Access Compliance Report

Public Rights-of-Way

(Curb Ramps)

Intersection ID: 53776	Main Street: ELEANOR_RIGBY_RD	Cross Street: CHAPECLANE_RD	Location: SW
ADA ID: F1B9DBA29737	Ramp Type: BlendTrans1	Initial Pass/Fail: Fail	Overall Compliance: No
		Severity Score: 1.25

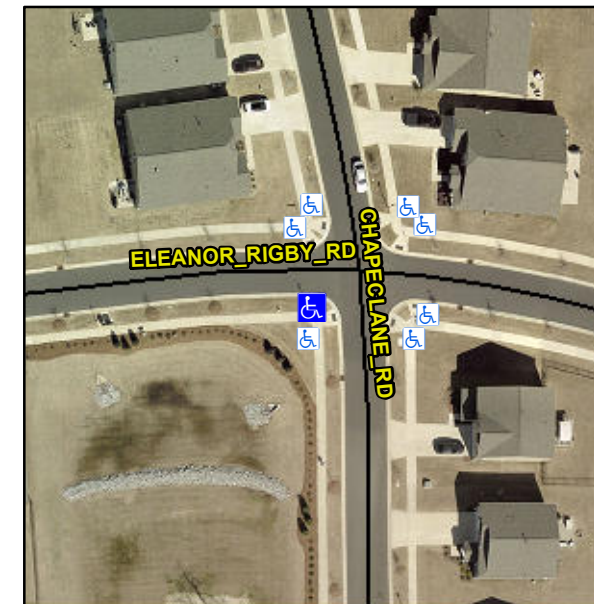
Not Found, R304.5.3

Compliance	Description	Data	Compliance	Description	Data
N/A	Ramp Length (in)	98.0	Yes	BlendTrans Slope (%)	4.6
Yes	Ramp Width (in)	48.0	No	BlendTrans XSlope (%)	3.9
N/A	Flare Type LT	N/A	N/A	Flare Type RT	N/A
N/A	Flare Slope LT (%)	N/A	N/A	Flare Slope RT (%)	N/A
N/A	Flare Traversable LT?	N/A	N/A	Flare Traversable RT?	N/A
N/A	Landing Length (in)	N/A	N/A	DWS Provided?	N/A
N/A	Landing Width (in)	N/A	N/A	DWS Contrast?	N/A
N/A	Landing Slope (%)	N/A	N/A	DWS Length (in)	N/A
N/A	Landing X Slope (%)	N/A	N/A	DWS Full Width?	N/A
N/A	Landing Curb? (Y/N)	N/A	N/A	DWS Offset (in)	N/A
N/A	Shared Landing?	N/A			
N/A	Gutter Ponding?	N/A	N/A	Gutter Slope (%)	N/A
N/A	Gutter Lip Ht (in)	N/A	N/A	Gutter X Slope (%)	N/A
N/A	Painted X Walk1?	No	N/A	Painted X Walk2?	N/A
	X Walk 1 Direction	To N		X Walk 2 Direction	N/A
	X Walk 1 Width (in)	N/A		X Walk 2 Width (in)	N/A
	X Walk 1 Slope (%)	1.3		X Walk 2 Slope (%)	N/A
	X Walk 1 X Slope (%)	1.3		X Walk 2 X Slope (%)	N/A

N/A	Ramp inside XWalk1?	N/A	N/A	Ramp inside XWalk2?	N/A
	Road Slope (%)	1.3		Clear Space?	N/A
	Road X Slope (%)	1.3	N/A	Clear Space to XWalk (in)	N/A
N/A	Any Obstructions?	N/A	N/A	Storm Grate/Utility Hazard?	N/A
	Obstruction Type			Storm Grate/Utility Type	
		N/A			N/A
			Yes	Surface Condition? (G/P)	Good
			No	Curb Slope (%)	5.8

Remove & Replace Curb Ramp With Two New Directional Ramps or Equivalent.
